Notice of Meeting  
Polk City | Planning and Zoning Commission (P&Z)

## PRELIMINARY PLAT REVIEW

Date: November 14, 2019  
 Project: Creekview Estates

Compiled by: Kathleen Connor, Planner  
 Project No.: 119.0842.01

CREEKVIEW ESTATES  
PRELIMINARY PLAT

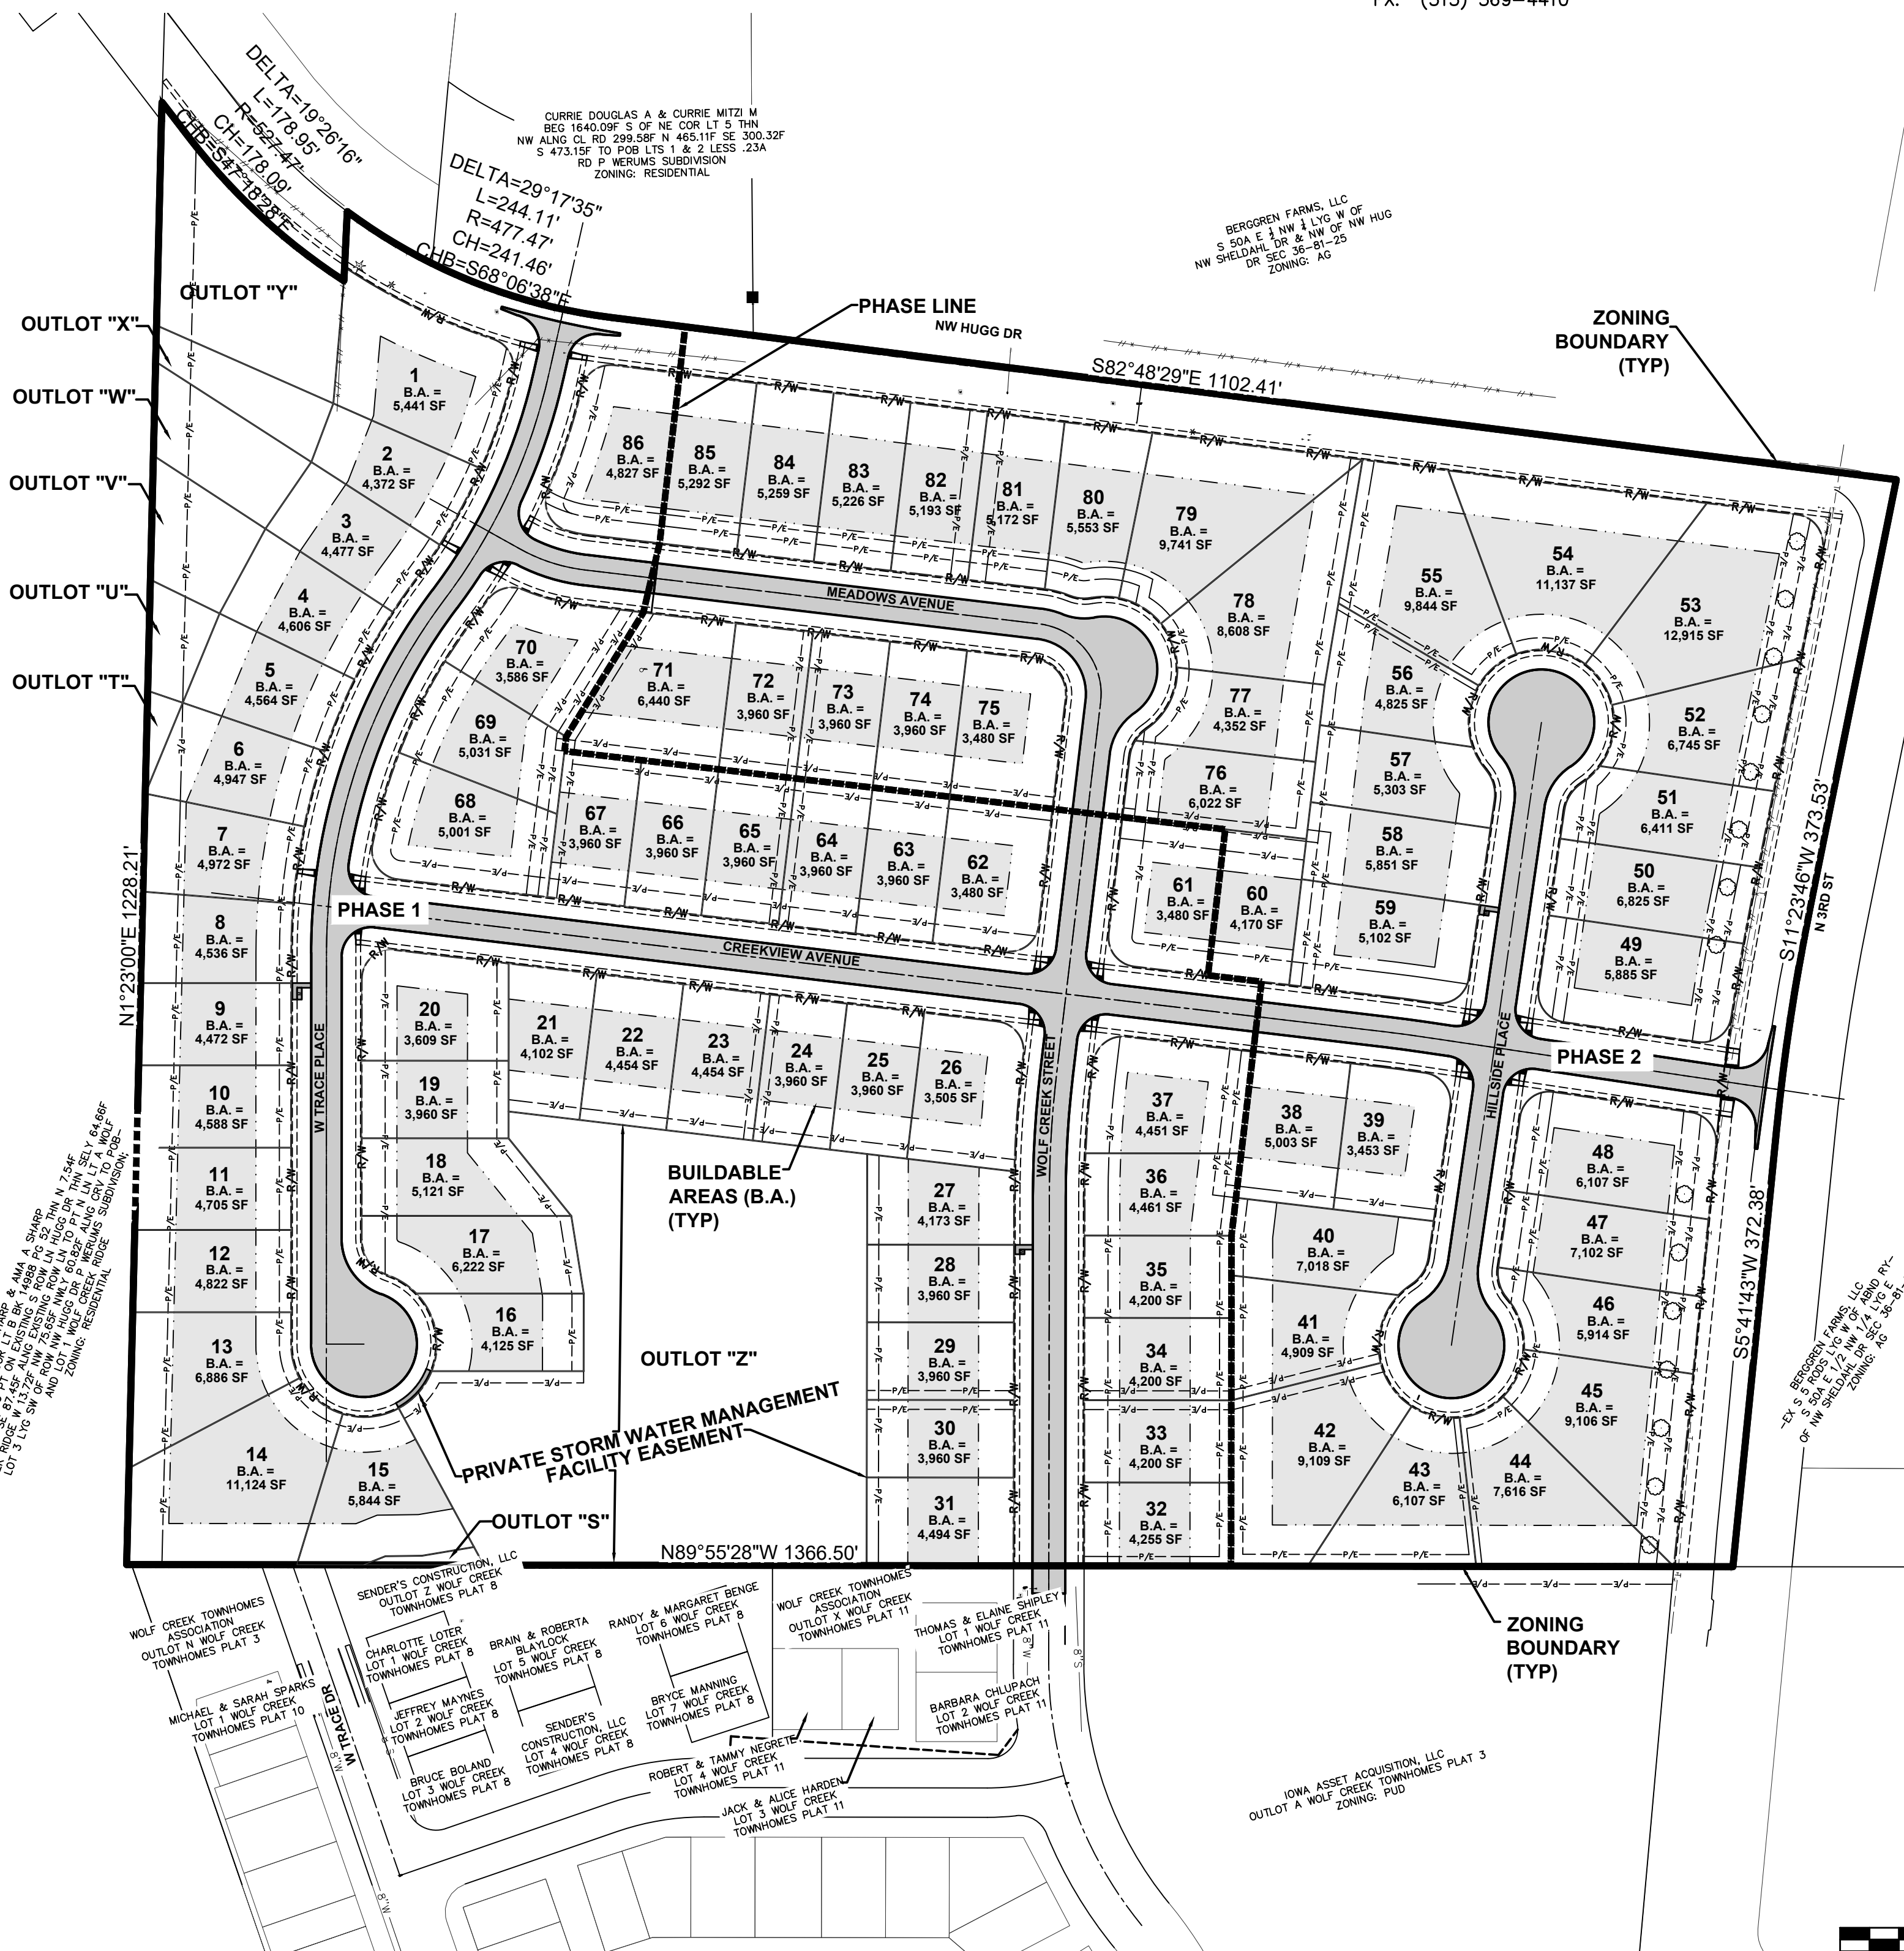
1. Revise Wolf Creek Street to Wolf Creek Drive to match existing connecting street. Revise Meadows Avenue to Meadows Court since it is a short street.
2. Add two notes that read "The minimum opening elevation (M.O.E.) shall be the elevation of the lowest opening." and "The minimum basement elevation (M.B.E.) shall be the elevation of the lowest floor, including basement."
3. Label the detention basin on Page 4 as a "Private" Storm Water Management Facility.
4. Show the 10' wide recreational trail as a proposed plat improvement, and label accordingly. As discussed above, the cost of additional pcc pavement for the 10' trail compared to a 4' sidewalk will be a credit toward the park land dedication.

5. Add two parkway trees, one on each side of Creekview Avenue.
